REGIONAL REVIEW FINDING

ARC REVIEW CODE: R508022

Submitting Local Government: Henry County
Name of Proposal: Mill Road Tract

Preliminary Report:	August 2, 2005	DEVELOPMENT OF REGIONAL IMPACT REVIEW REPORT	Project:	Mill Road Tract # 807
Final Report Due:	Sept 1, 2005		Comments Due By:	August 16, 2005

PRELIMINARY CONCEPT PLAN

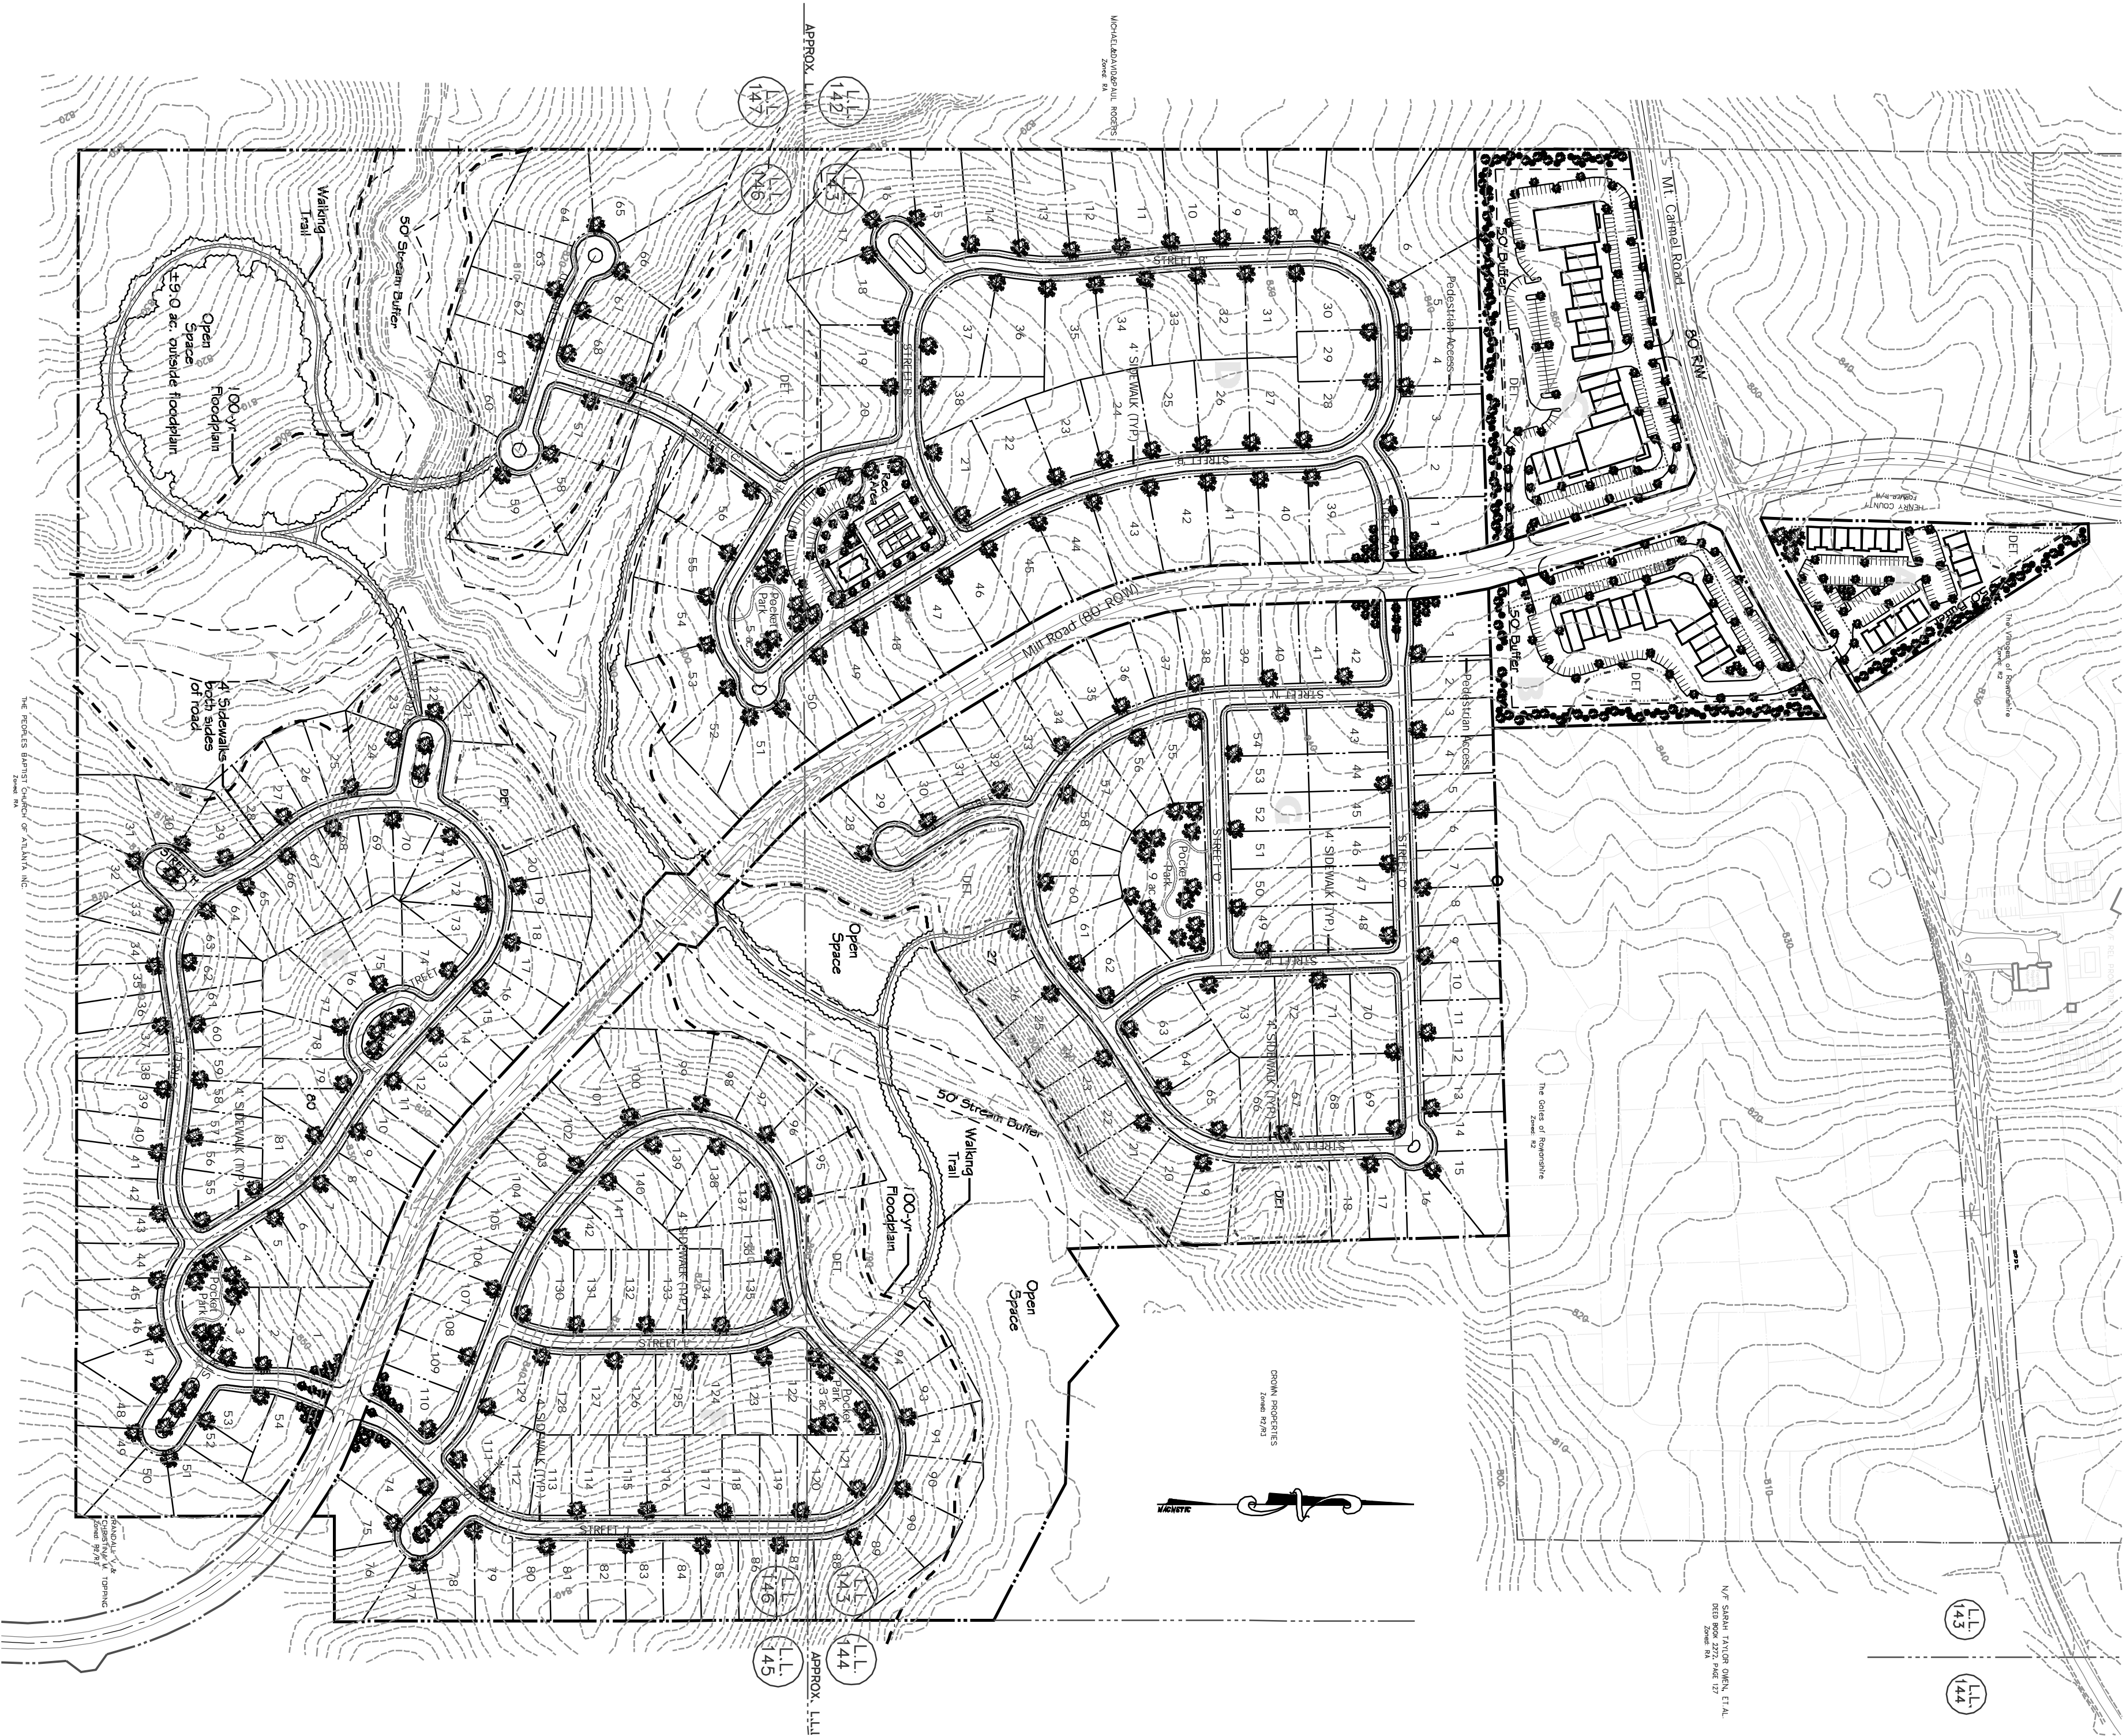
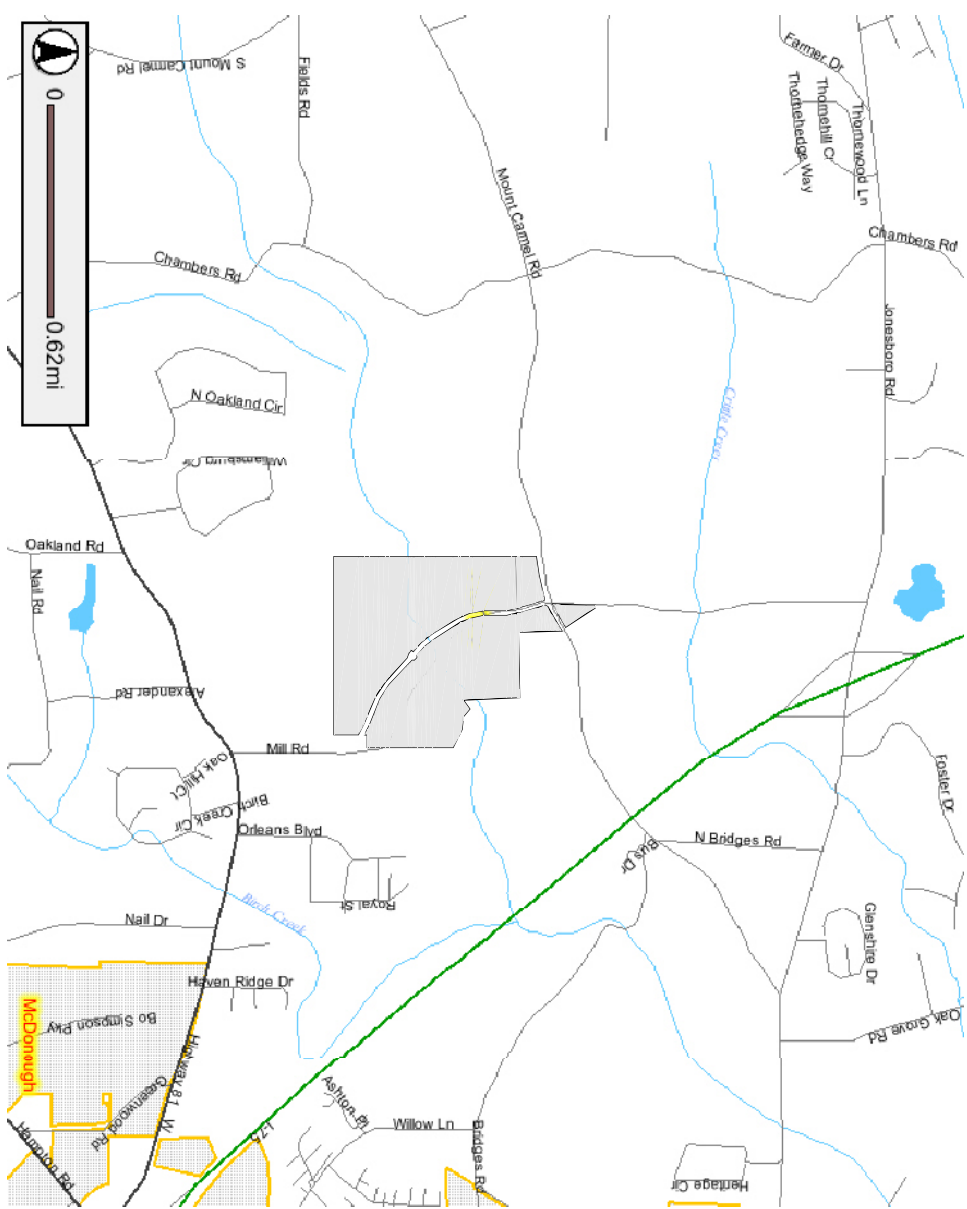
The stream crossing for twelve residential lots on the southwestern portion of the property seems unnecessary. It is recommended that the site plan be revised to reflect a more compact form. Pedestrian connections alternative to the road and sidewalks should be provided to the commercial component from the residential, where possible, including a pedestrian connection to The Gates of Rowanshire and The Villages of Rowanshire. Alternative pedestrian access to the church, school, and ball fields immediately south of the residential component should be provided where possible.

The proposed site plan incorporates interconnected streets throughout the residential portion of the development. Where the streets are unable to connect due to the stream and 50' stream buffer, the site plan incorporates a walking trail that allows pedestrians to access other areas of the proposed development, particularly the recreational area and pocket parks, without having to use the automobile. ARC promotes interconnected streets and alternative pedestrian connections through its RDP Policies and Best Practices listed below.

The commercial portion of the site is well suited to provide basic services and goods for the residents of this proposed development as well as other residential developments in the immediate area. However, the commercial portion of the proposed development could be revised to reflect a more pedestrian oriented development centered on the intersection. The parking that is proposed along Mill Road and Mt Carmel Road, essentially in front of the commercial buildings, could be relocated to the back, placing the building up along the street.

The stream crossing for twelve residential lots on the southwestern portion of the property seems unnecessary. It is recommended that the site plan be revised to reflect a more compact form.

Pedestrian connections alternative to the road and sidewalks, should be provide to the commercial component from the residential, where possible, including a pedestrian connection to The Gates of Rowanshire and The Villages of Rowanshire. Finally, signage and road marking should be included to ensure safe access for pedestrians from one portion of the development to the other where internal residential streets across over Mill Road. Alternative pedestrian access to the church, school, and ball fields immediately south of the residential component should be provided where possible.

The current site plan does not clearly indicate how stormwater runoff will be managed. In order to address post-construction stormwater runoff quality and quantity, the project should implement stormwater management controls (structural and/or nonstructural) as found in the Georgia Stormwater Management Manual (www.georgiastormwater.com) and meet the stormwater management quantity and quality criteria outlined in the Manual.
